PROPOSED SUMNER SENIOR AGING IN PLACE COMMUNITY

SUMNER SENIOR HOUSING APARTMENT COMMUNITY

PRELIMINARY SITE PLAN

Project Number:	DR-2023-0004
Project Representative:	Synthesis-Interests 1610 33 rd Avenue Seattle, WA 98122
Project Address:	15403 Main Street E Sumner, WA 98390 (Parcel# 0520193122) and parcels 0520193045, 0520193112 and 0520193177.
Project Components:	Design Review for construction of a senior apartment community, within a new 4-story apartment building approximately 15,00 SF building. Project includes on-site parking, commercial required pedestrian spaces, on-site common open space and site landscaping.
Related Permits:	SEPA, Planned Residential Development Permit, Boundary Line Adjustment, Demo, Civil and Building permits required.
Date of Meeting:	April 12, 2023
Staff Representative:	Chrissanda Walker– Associate Planner
Attachments:	Site Plan, landscaping plan, building elevations, building renderings and building material list.
Recommendation:	Recommend to approve with conditions

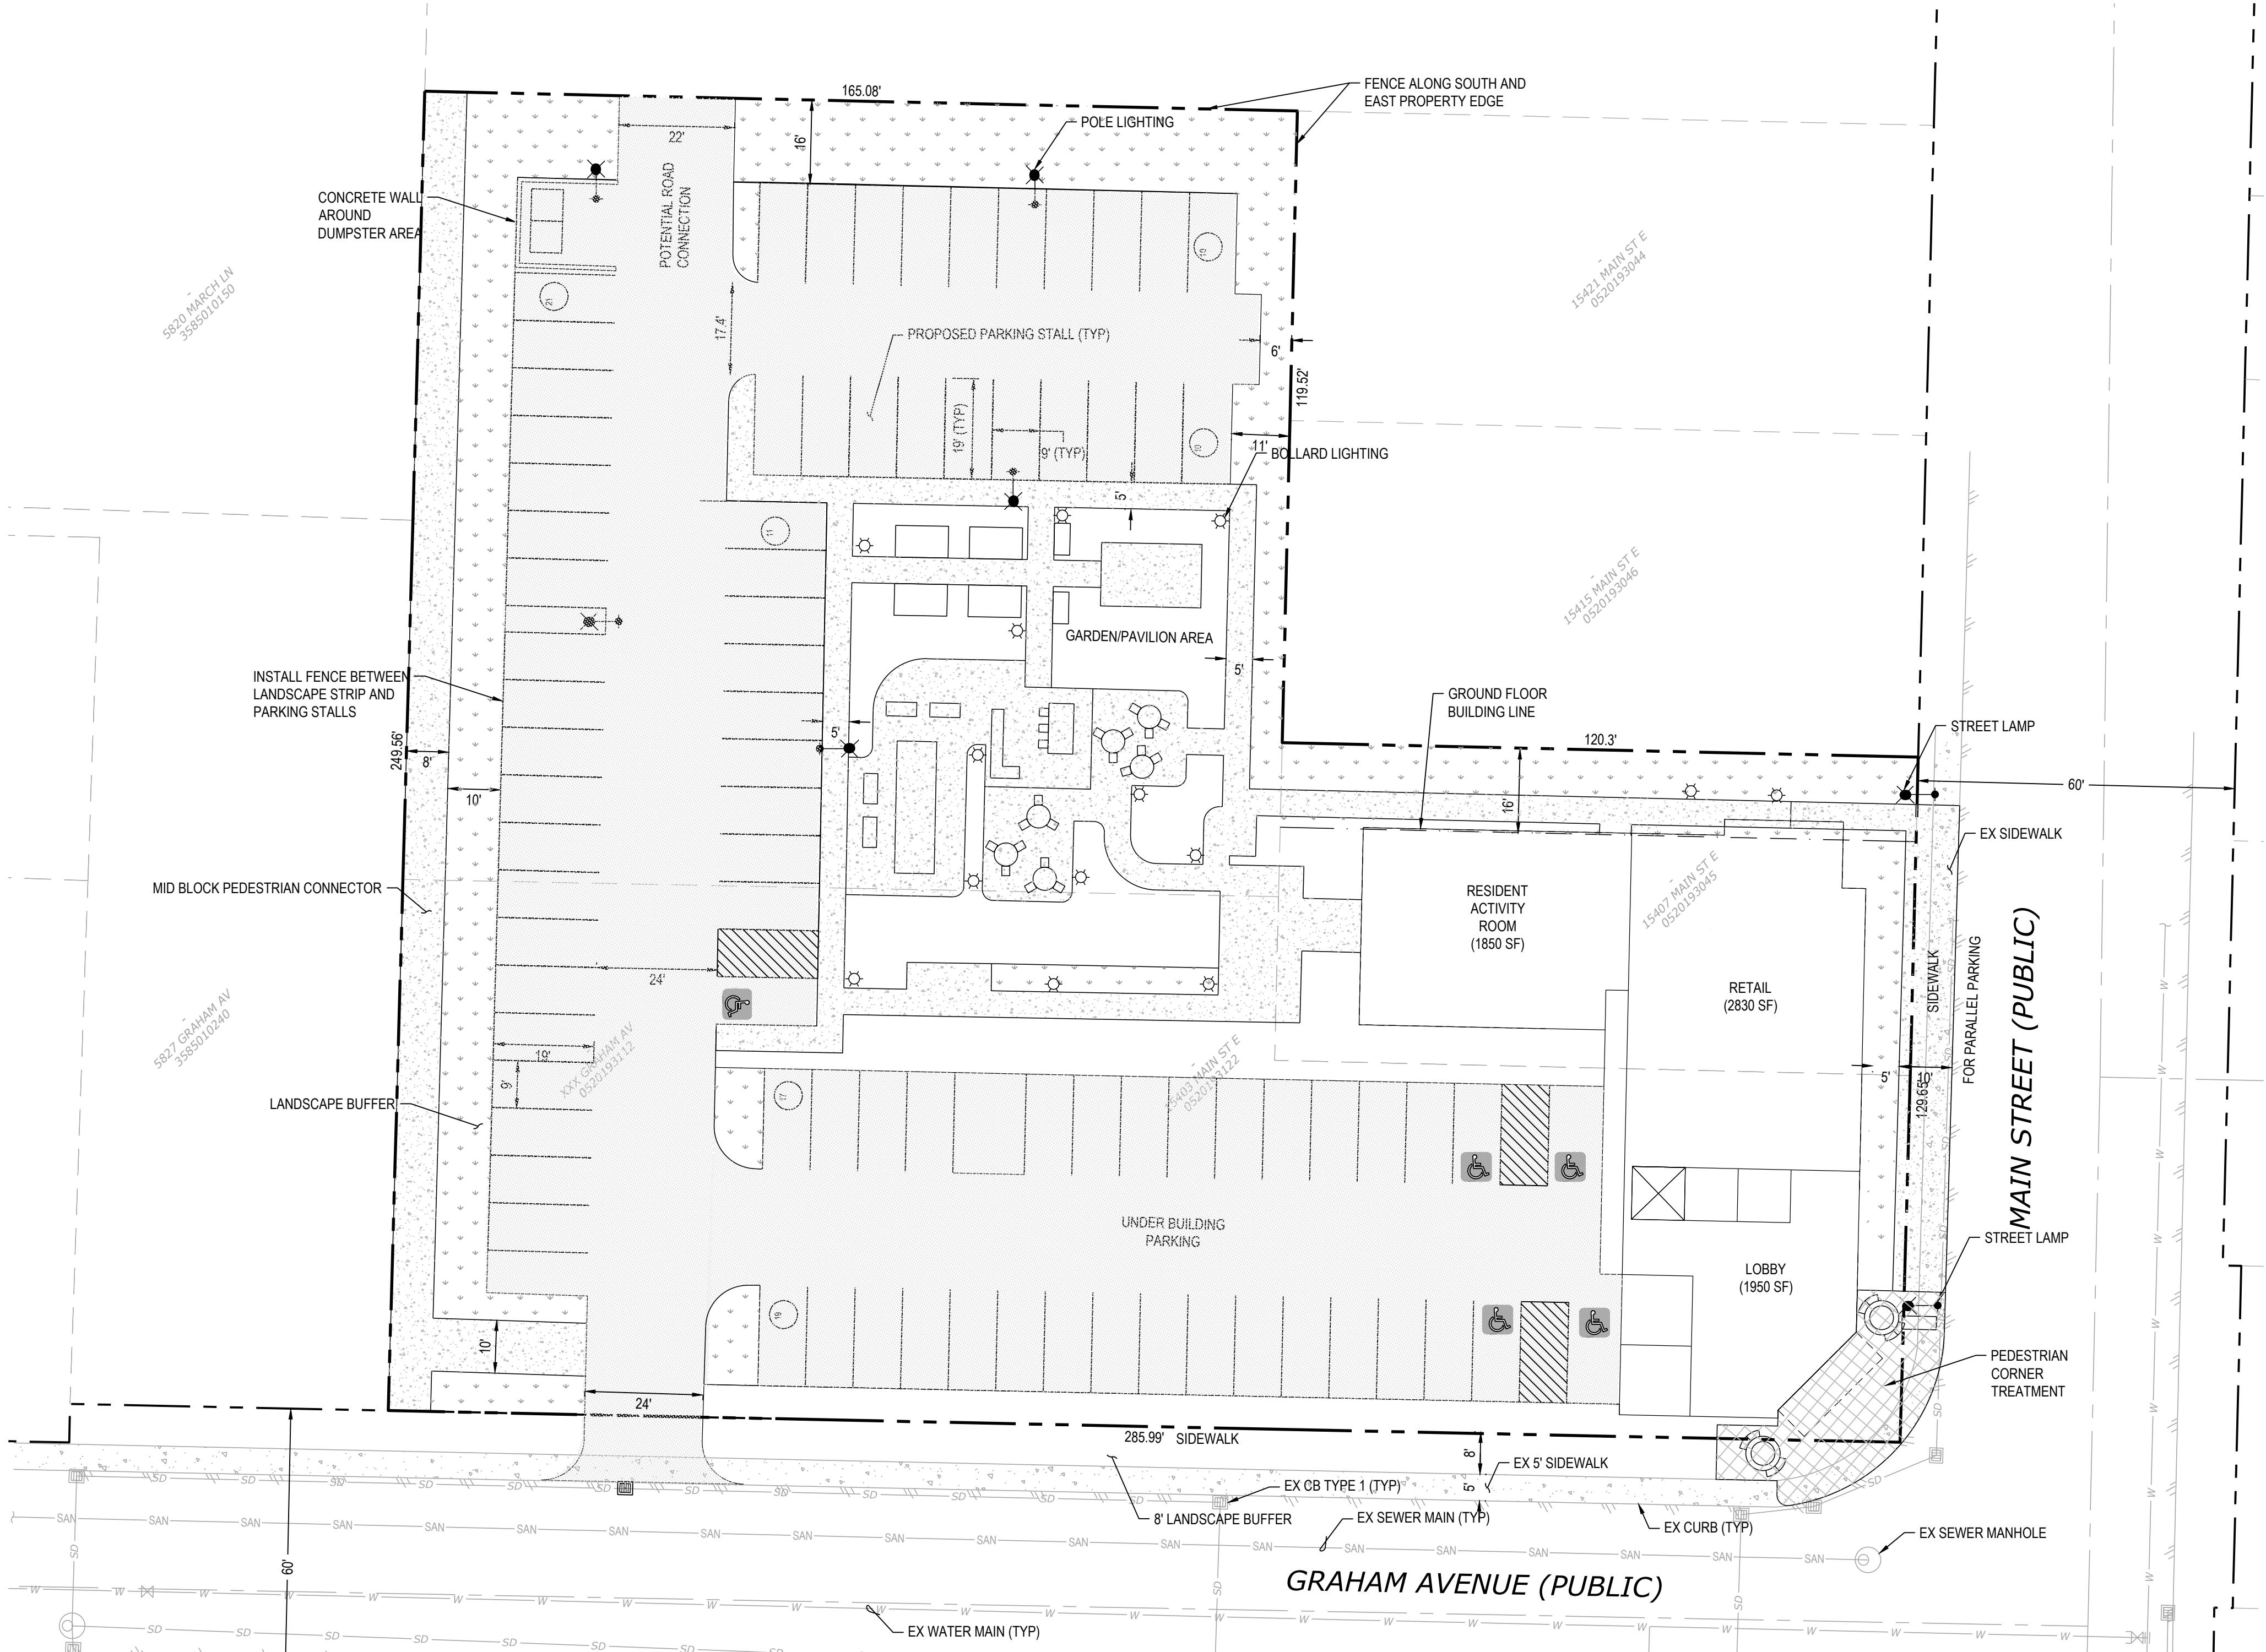
The site plan shows the required 10-foot-wide sidewalk along Main Street and a proposed building setback of 5-feet and this is not consistent with the above evaluated building location guidelines. Reduced setback would be considered, provided the proposed landscaping and building design treatments add visual interest to the street and create a comfortable environment for pedestrians. Evaluation of the proposed front facade are as follows:

roughly 76% of the secondary street frontage, Graham Ave. Within this portion of 8 feet wide of landscaping along the western façade of the structure, it appears that Type C landscaping is not proposed, which would call for trees to be planted at 20 feet on-center with a minimum 2" caliper at installation. Above this landscaped area is the extended concrete canopy ledge, which may interfere with tree growth. To enhance the screening between the sidewalk and the under-building parking areas, the project should install a trellis for climbing plants to add vertical landscaping where trees would not fit.

Surface parking is proposed in the rear, parked in parallel orientation with the street. The first surface parking stall from Graham Ave is setback approximately 20 feet from ROW, with the opportunity to provide dense landscaping and installation of a walkway for internal circulation, between the ROW and the surface parking area. If pedestrian utilization is desired at this corner, and for the purposes of parking lot screening, the project should aim to meet subsection c) of this guideline, by installing an elevated planter with ledges that are approximately 12 inches in width to double as seating within this NW landscape corner. As a recommended condition of approval, an elevated planter with ledges should be constructed of brick, stone, or decorative concrete that is complimentary to the overall building design. This would provide visual interest and enhance pedestrian utilization, while helping to define the street edge and satisfying this parking lot screening. Further parking lot screening around the rear of the lot, which will face the new public-mid-block connections, will include a fence line proposed between the landscaping strip and parking stalls. The construction of the fence provides adequate screening of parking and would allow for the reduction of the landscape buffer to a minimum of 5 feet. Evergreen tree species are called out under another guideline to be installed along this buffer, so at the very least this landscape buffer should be reduced to 8 feet wide in order to comply with condition #19 below regarding the mid-block connection development. The width of a new mid-block connection shall be a minimum of 10 feet. Maintaining Type B or C landscaping within the buffer will provide necessary screening to meet the intent of this guideline. As conditioned, this guideline is satisfied.

The site proposes a row of 21 parking stalls along the north property line, located in the rear of the site. At least one landscape island of 5 feet wide should be constructed within this row of parking. At least one shade tree should also be planted within this strip. Adequate parking landscaped areas surrounds the site. No more than 10 parking spaces area proposed in a row surrounding the outdoor open space. Where these parking stalls abutt a pedestrian walkway, wheel stops shall be required. As conditioned, this guideline is satisfied.

- a. Raised planters shall be used along the primary street frontage, within the 5 foot setback and shall be constructed with stone or brick material that will be complimentary to the building design;

- a. To enhance the screening between the sidewalk and the under-building parking areas, the project should install a trellis for climbing plants to add vertical landscaping where trees would not fit.

- b. To accentuate a visual screening of the surface parking lot at the NW corner of the site, a 5-foot-wide elevated planter with ledges 12 inches thick should be constructed of brick, stone, or decorative concrete that is complimentary to the overall building design.

BUILDING FACADE ARTICULATION MAIN ST E & GRAHAM AVE

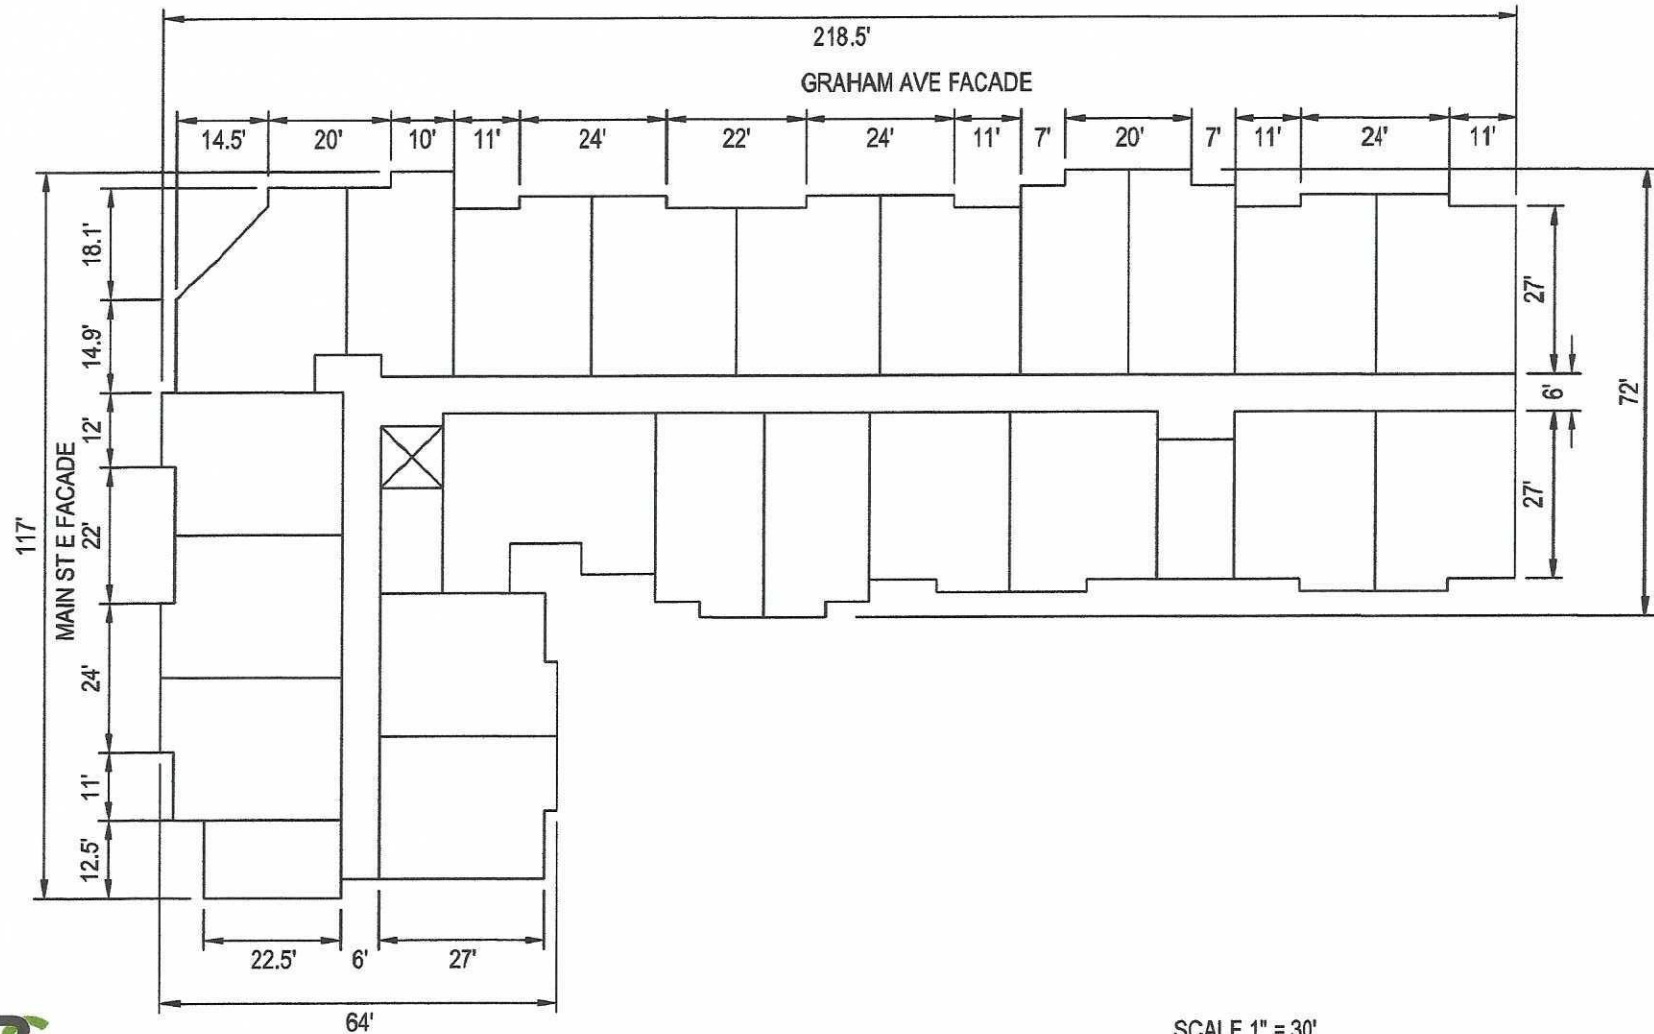
The Main Street facing facade (south elevation) includes the use of windows and storefront entrances that reinforce the patterns of storefront spaces along the ground story. The proposed design incorporates the use of brick and the FRC panels to provide a mix of materials. Changes in building materials and increasing window transparency may not be adequate enough to qualify under this guideline. Articulation should be encouraged with a change in the canopy line. Cantilevered awnings above the commercial storefront entrances can break the straight line of the concrete overhang and as discussed under building details guidelines below would qualify as a decorative item. Staff would recommend that a change in the canopy line and material type should be shown above the main entrance and the commercial entrance to emphasize the façade articulation. As conditioned, this guideline is satisfied.

The ground story elevation along the street includes a proposed use of red brick pattern around the base of the ground story, with a mix of fiber reinforced concrete. Staff would recommend that brick material be utilized along the entire ground story. Concrete overhangs above appear to extend all along the facades to provide a break at the first-floor height. The middle stories incorporate one material type for the building façade, FRC panels in two-tones, cannery yellow and a turquoise blue. Vertical articulation through the middle of the building includes some material changes with the use of the railings along the balconies, and designing portions of the building to be setback increases modulation. Along the top of the building, rooflines are sloped along various sections of the building that provide adequate vertical articulation. This guideline is satisfied.

8. **DG 2.3.4 Façade Articulation along East Main Street.** Project should show a change in the canopy line and a different material type for an awning above the main entrance and the commercial entrance to emphasize the façade articulation.

- a. Brick should be used in a decorative manner and be applied around the entire main entrance and provide a natural transition between brick and FRC panel materials.

POLE LIGHT FIXTURE
ARIA CALIFORNIA
MODEL

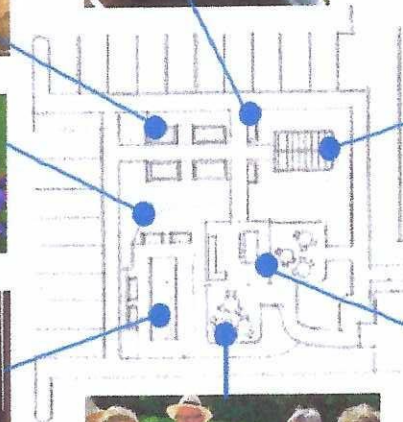
Under the building materials exhibit provided, the project shows two proposed lighting examples, pole light and bollard fixtures constructed of black steel or aluminum material. The bollard light fixtures are proposed within the outdoor garden amenity area, which is satisfactory for pedestrian use. There are 5 parking lights proposed as the black pole lights and will be limited to the height limits provided herein. As a condition of approval, at site development permits project shall provide a lighting plan and details consistent with this guideline. This guideline is satisfied.

13. **DG 2.5.4 Site Lighting.** At site development permits project shall provide a lighting plan and details consistent with this guideline.
14. **DG 2.5.6 Side and rear yard buffer requirements:**

FEATURES CORNER PEDESTRIAN ORIENTED SPACE

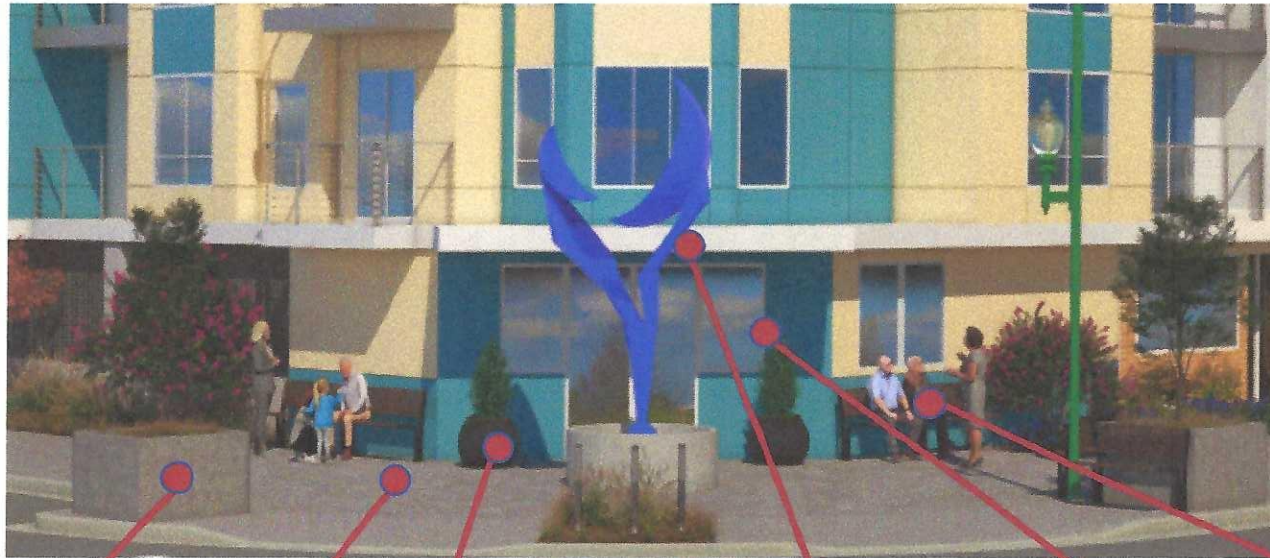
The project proposes to add two raised planter pots at the notched entrance on each side of this main entranceway, and 8-foot-wide benches proposed along each street facing façade. The project will provide pedestrian corner treatment further evaluated under These elements are great pedestrian features to include along the main entrance. Any proposed raised planters within the ROW are not reviewed under this guideline, and could require ROW occupancy agreements, approvals sought through the Public Works department.

In order to comply fully with these guidelines, staff would recommend that the design of the raised planters be complimentary to the brick facades and the distinction of the awning material be further clarified. There is a concrete overhang that appears to provide weather protection at least 5 feet in width along at least 75 percent of the total primary street facing façade. A distinguished awning material and design should be utilized above the main entrance. To approve the reduced setbacks and as a condition of approval, a pedestrian oriented façade along Main Street shall include raised planters constructed with stone or brick material that will be complimentary to the building design and this project shall provide at a minimum 50% transparency for the ground floor façade between 4 feet and 8 feet. This guideline is satisfied as conditioned.

The main entrance for this project is located at the corner and the building step backs approximately setback 20 feet from the corner property line, and a 5 foot wide awning is proposed along the entire entrance façade, which measures approximately 23 feet long. This provides for adequate pedestrian-oriented space to be developed at this street corner and further evaluated under DG 2.2.5. The building also uses modulated step backs to provide visual changes at corners. This guideline is met.

- b. This project shall provide at a minimum 50% transparency between the range of 4 feet and 8 feet along the ground story.
2. **DG 2.1.4 Parking Area Screening.**

6. **DG 2.2.5 Pedestrian-oriented space.** To qualify the main entrance as pedestrian- oriented space, the project shall provide decorative building-mounted lighting at the main entrance and the commercial entrance along the street fronting façade, no more than 14 feet in height.
